STATE OF ILLINOIS  
DEPARTMENT OF TRANSPORTATION

Contract # 98994

**CONCRETE PARAPET  
SLIPFORMING OPTION**

**SECTION**  
(Showing dimensions)

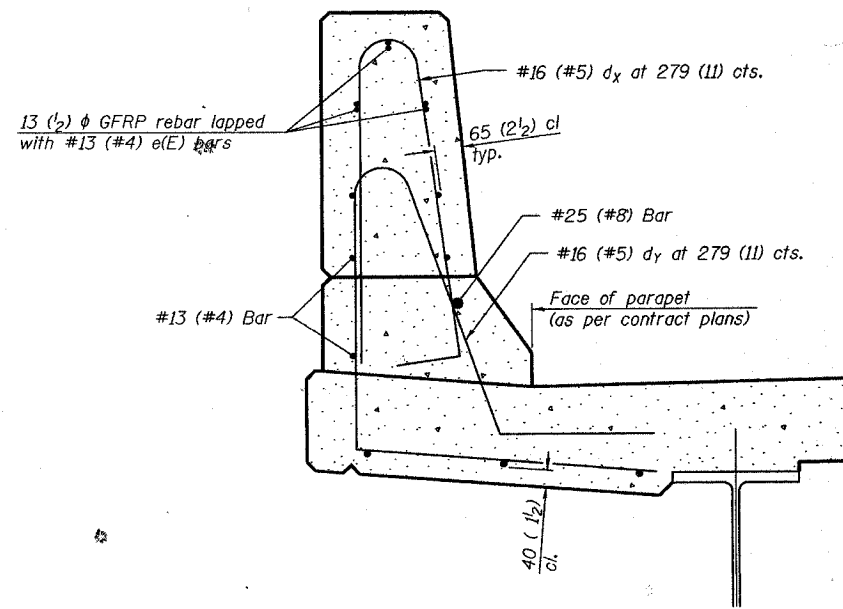
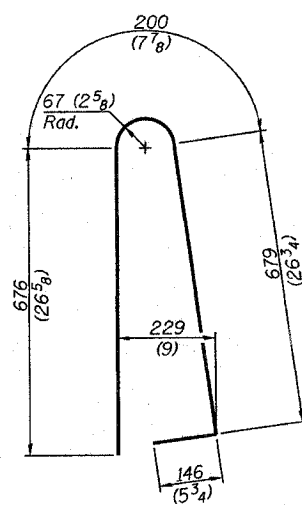
**GENERAL NOTES**  
All dimensions shall remain the same as shown on contract plans, except dimensions A and B which are to be revised as shown to provide additional clearance. Additional concrete needed to revise dimension A and B = 0.0422 m<sup>3</sup>/m (.0165 cu. yds./ft.) of parapet. Place aluminum sheet in curb portion at and near piers. Full thickness saw cut at all other locations. Adjust/add joint locations to maintain 3 to 6 meter (10 to 20 foot) spacing.
